## Product Change Notice (PCN)

**PCN Number:** PCN-0334008R-01

**CMC-5044PF-A**  
**CMC-5042PF-AC**  
**CMC-2742PBJ-A**

#### CMC-5044PF-A

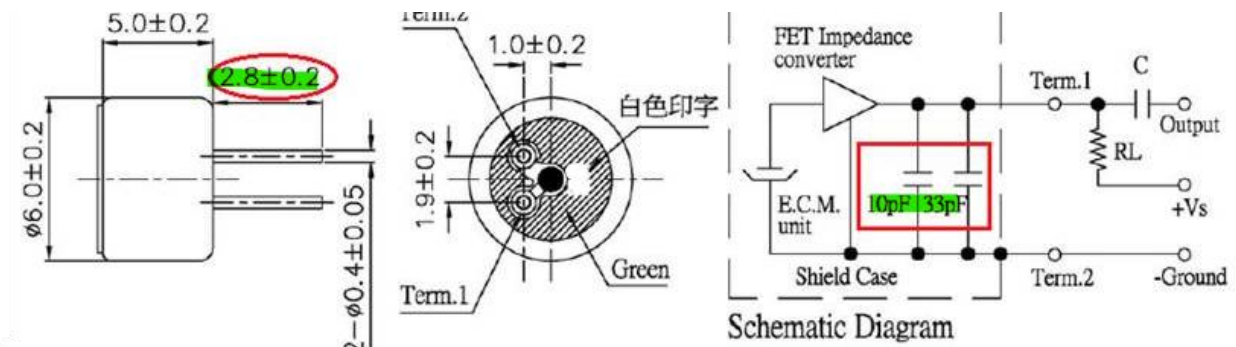
To ensure lead times are not being extended with shortage of material we have changed to a new PCB supplier and will be using a PCB with a 2.8 mm pin length and a 10pf + 33pf capacitor. Adding the two additional capacitors will be helpful on anti-interference at high frequency.
